City of Sunnyvale Memorandum

To: Planning Commission
From: Shaunn Mendrin, Senior Planner, AICP 
Date: May 22, 2013
Re: 2012-7986 726 San Miguel Avenue (*Continued from May 13, 2013*)

SUBJECT: **Jasbir Tatla:** Application for a project located at **726 San Miguel Avenue** in an R-0 Zoning District (APN: 205-14-030):

Motion **2012-7986** – Design Review to allow a new two-story single-family home resulting in 2,804 square feet and 53.5% Floor Area Ratio (FAR).

② BLOCK DIAGRAM SECOND FLOOR

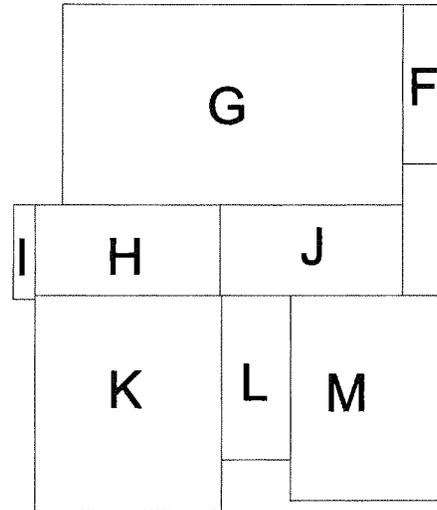
The neighborhood for this site is composed entirely of single-story homes. The original proposal included a second floor area of 1,009 square feet, or approximately 51.8% of the 1,949 square-foot first floor area. The revised project includes a smaller second floor area of 953 square feet, which is approximately 51.5% of the 1,851 square-foot first floor area. While the second floor area was reduced slightly, the first floor area was also reduced and the overall proportion of first to second floor area remains about the same. As a result, staff finds the project is still not in compliance with the Design Techniques related to second floor area. Although Design Techniques for reducing second-story bulk have been included in the project design, the bulk of the resulting second-story would still be out of character with the surrounding single-story neighborhood.

applicant has reduced the overall size of the home, the proposed FAR remains higher than typical FARs the neighborhood. In addition, the proposed design continues to have significant second-story bulk, with a second floor area equal to 51.5% of the first floor area. Floor plan changes including relocating bedrooms to the ground floor could be used to substantially reduce second floor area. However, the applicant has indicated he is unwilling to relocate any of the four proposed bedrooms.

- b) Reduce second floor area to no more than 35% of the first floor area. The modified design shall be generally consistent in style, character, and detail with the current project plans.

① PROPOSED FIRST FLOOR PLAN

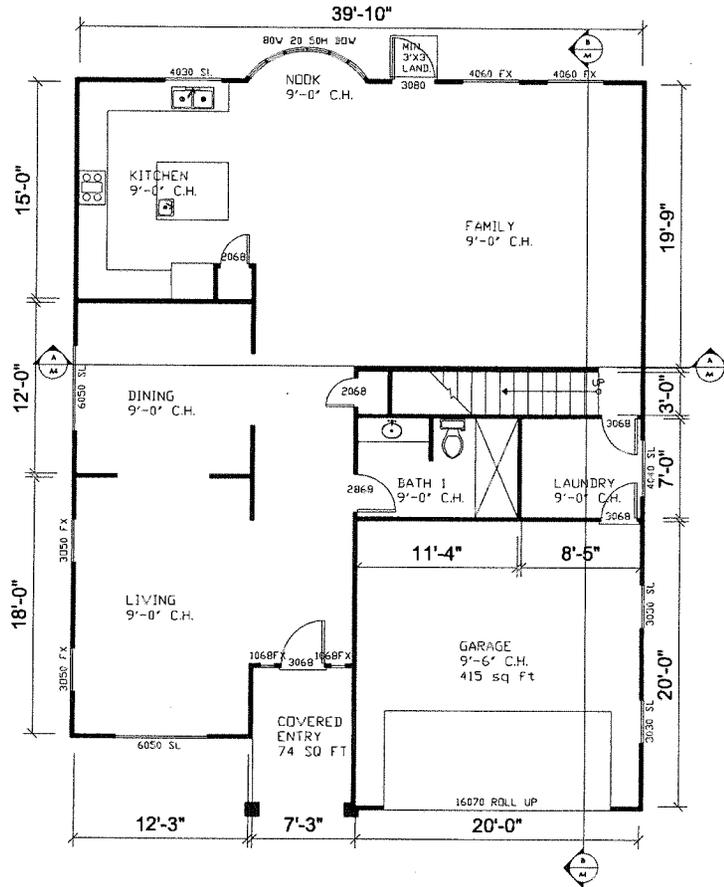
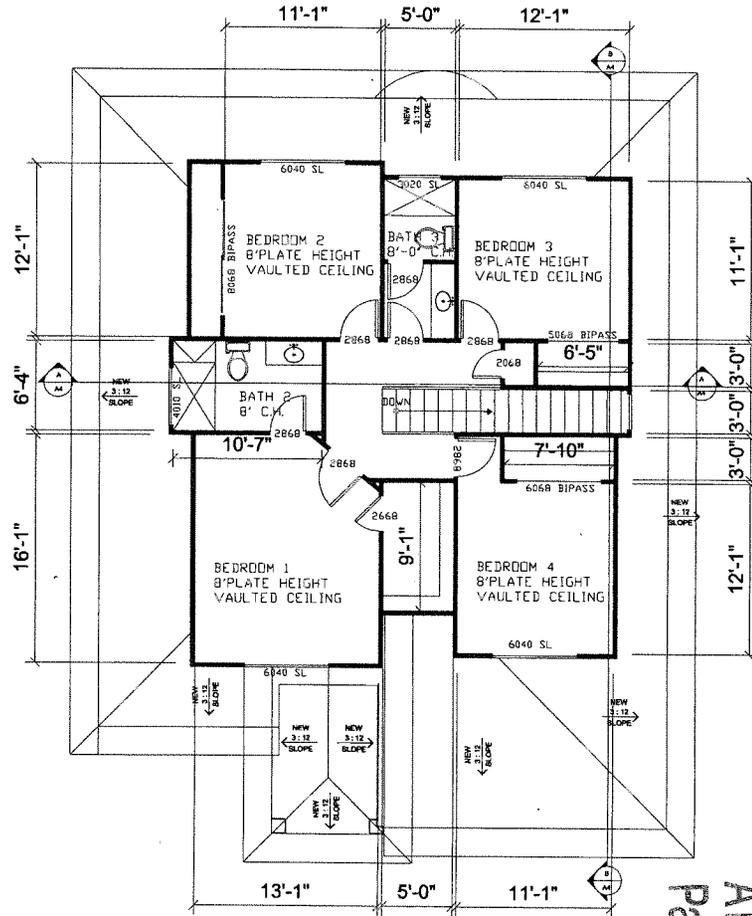
Second floor windows on side elevations are few and are designed to minimize privacy impacts (3.6.C). A small high-sill bathroom window is proposed on the left side elevation and a larger stairway window is proposed on the right elevation. Based on the location of the stairway landing, this window is not expected to have privacy impacts on adjacent neighbors.

- PS-1. REQUIRED REVISIONS TO PROJECT PLANS:
The plans shall be revised to address the following:
- a) Reduce floor area ratio to no more than 52%. The modified design shall be generally consistent in style, character, and detail with the current project plans.

② LEFT ELEVATION 1

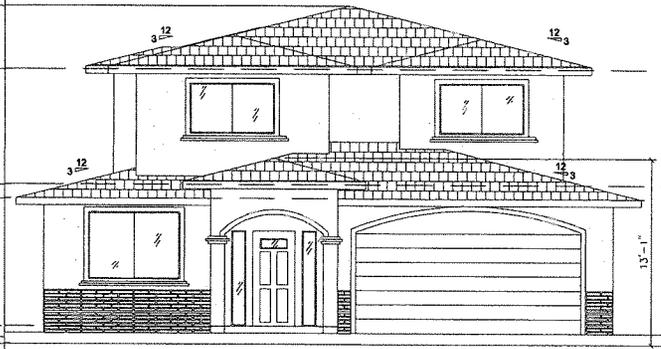
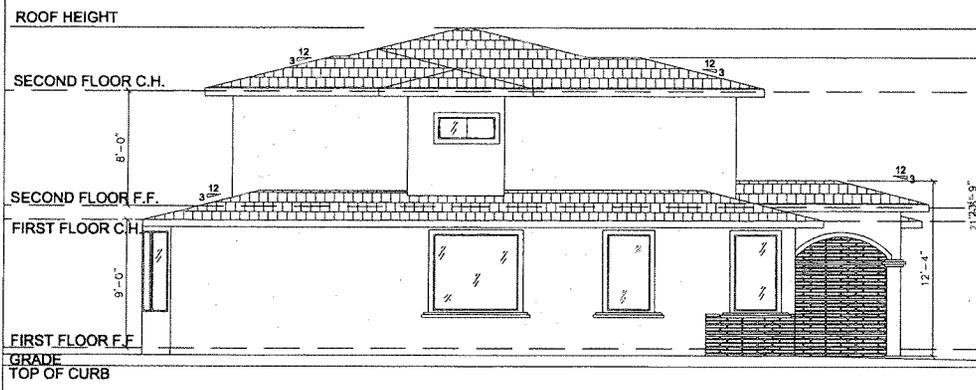
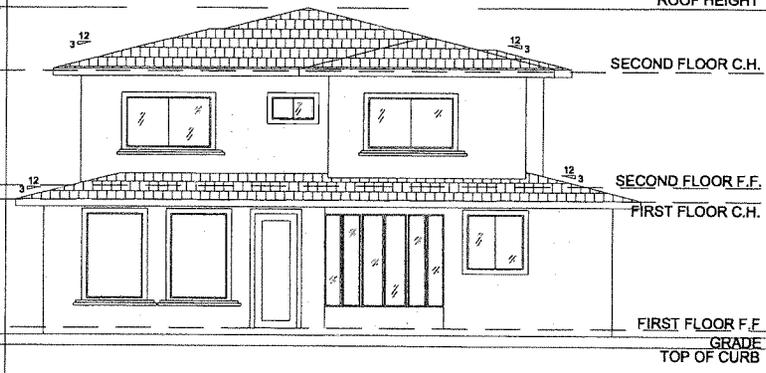
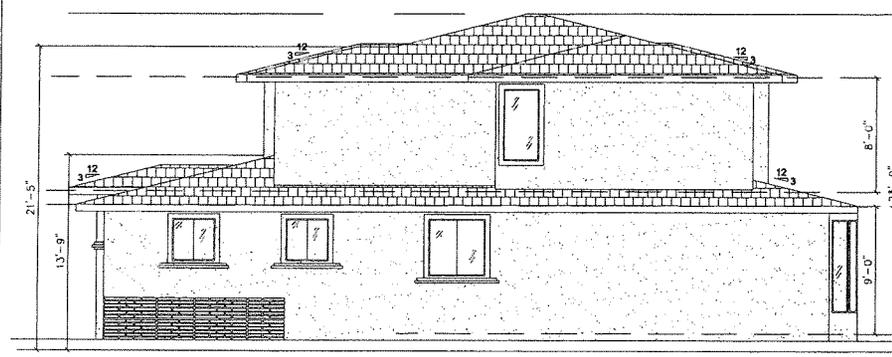
The existing home has simple Ranch-style architecture with hip roofs, stucco wall materials and composition shingle roofing. The majority of homes in the immediate neighborhood have the same style and materials. The proposed home would be in a contemporary style and would continue to use a hip roof design and primarily stucco wall materials. Other materials include a stone base along the front façade and clay tile roofing. The proposed home would have a formal entry feature with its roof slightly higher than first-floor eaves. Wall plates on the first floor would be nine feet while second floor plate heights would be limited to eight feet. (See Attachment E – Project Plans.)

The overall architectural style and design features of the proposed home are generally consistent with the Single Family Home Design Techniques. The home entry has been located so it is visible from the street (Design Technique 3.3.A) and entry eaves are close to the height of first floor eaves (3.3.D). Second floor areas have been set back significantly from first floor walls (3.4.C). Exposed second-floor walls are limited in height and incorporate horizontal offsets to break up their massing (3.4.G and I), and second floor ceiling heights are minimized (3.4.H). A hip roof is proposed with a low pitch similar to roofs in the surrounding area (3.5.B and D).
